Option A / no-chair-rail comparison

OPTION A / NO RAIL - CHAIR RAIL UNDECIDED - REVIEW ONLY / DO NOT CUT

Chair rail remains UNDECIDED. Option A shows upper/lower frames without rail; the existing chair-rail design remains Option B for comparison. Original trim stays.

D04 / panel and art-cover interface

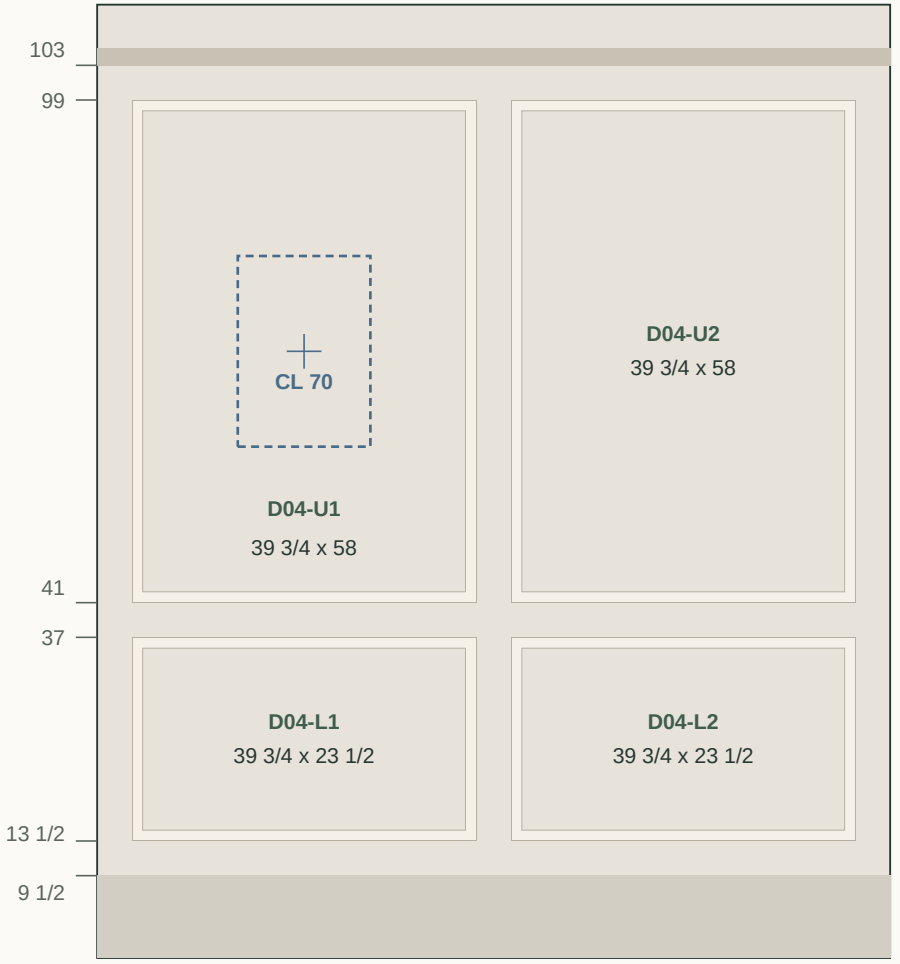
Use later derived W approx.91 1/2, not old 94-in illustration. Datum: outside window-casing edge toward the right inside corner.

Retain recorded panel CL 23 7/8 horizontally and 70 vertically. Upper frame centre is exactly 23 7/8,70. No D5 outlet.

Dashed 15.3 x 22 envelope is a catalog cover placeholder. Verify actual panel/trim, door opening and access before any cover or fixing detail.

Art-cover size, hinge/sweep and mounting are UNRESOLVED. No enclosure or access obstruction is approved.

Hallway / short fixed-wall pieces

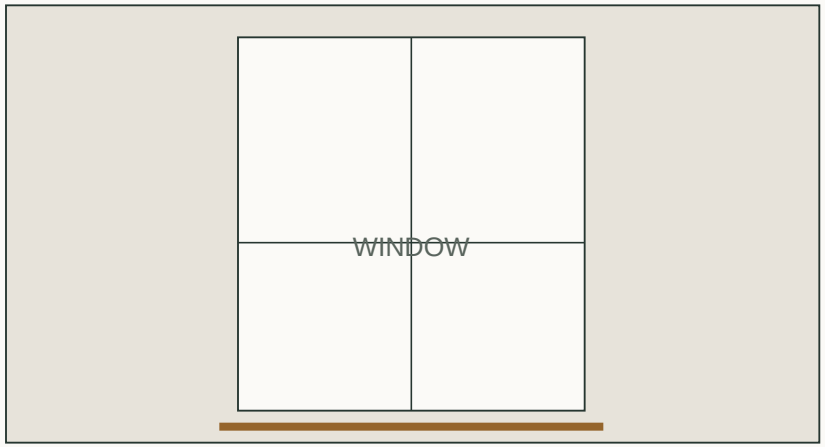
Option A studies aligned upper/lower pairs without rail on eligible fixed walls. Existing HA/HB/HC hall alternatives remain available; no final choice.

For N equal pairs and 4-in reveals: outside width=(P-4(N+1))/N. N remains a design decision after actual usable lengths and obstructions are recovered.

Base top, high trim, plates, casing changes and final door hardware are not verified here. Inherit no 61-in sample width or six-piece allowance.

H-P02 patch/services and H-P03 Murphy sweep must resolve before assigning a frame. Keep the door/bookcase face and moving envelope free of fixed molding.

H-W01 / L04 / BEDROOM B

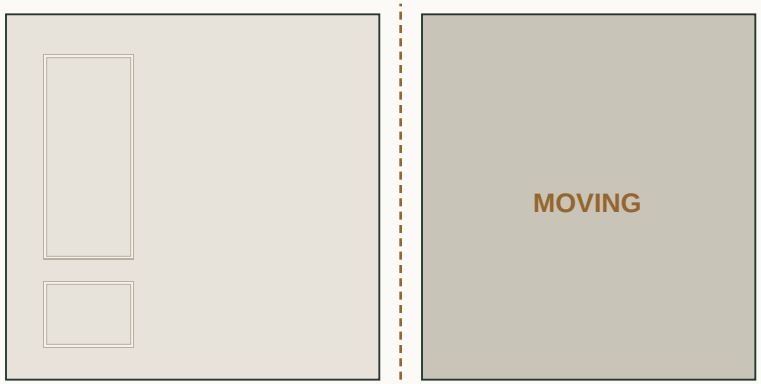
Hall H-W01: measure each pier and the below-window field independently. Place paired rows only where both fit; any below-window exception remains unresolved. No assumed equal widths.

Living L04 has an unresolved bay-wall/outlet reference, not a measured frame design. Keep it in the register; no invented frame count. Bedroom B remains the unframed east bay wall.

Terminate every fixed frame before casing/corner and the verified moving envelope. Proposed 4-in casing margin is measured from the OUTSIDE casing edge. No chair-rail end returns are needed.

Do not wrap a rectangle across a corner or bridge a door seam. H-P04 is a separate return, not part of the window face. Pocket backing/fastener depth and Murphy sweep remain unknown. NTS.

Bedroom installation / tape-fit separate pieces

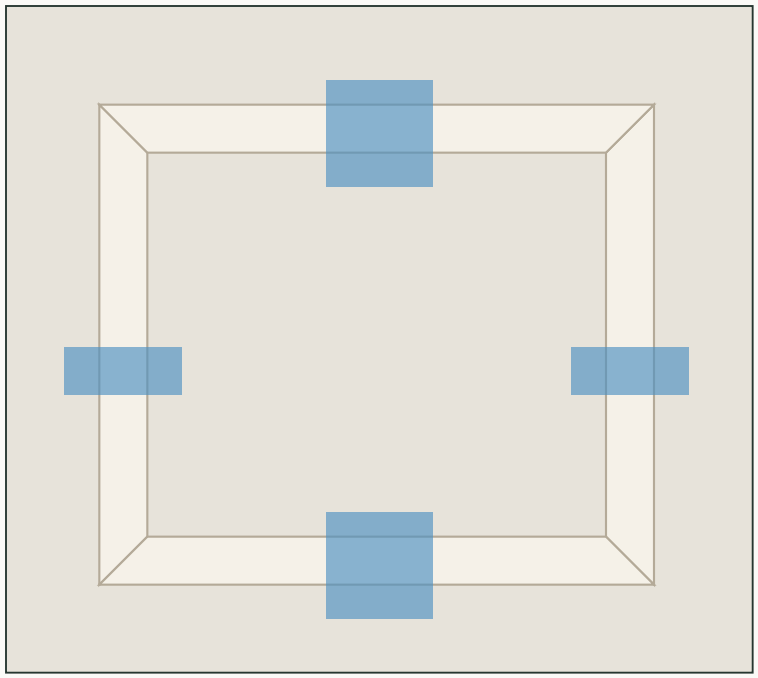
1. After layout approval, pencil the outside rectangle aligned to the retained trim. Check full cover plates, openings and fixing exclusions.

2. Cut and dry-fit four separate pieces directly on the wall. Hold them with painter's tape; inspect all four miters, reveals and alignment.

3. Then fasten each piece using the substrate/product-specific method. Remove temporary tape and finish joints after the assembly is checked.

This replaces R2 bench preassembly, square-jig and whole-frame mounting instructions. No adhesive, brad length or penetration depth is selected here.
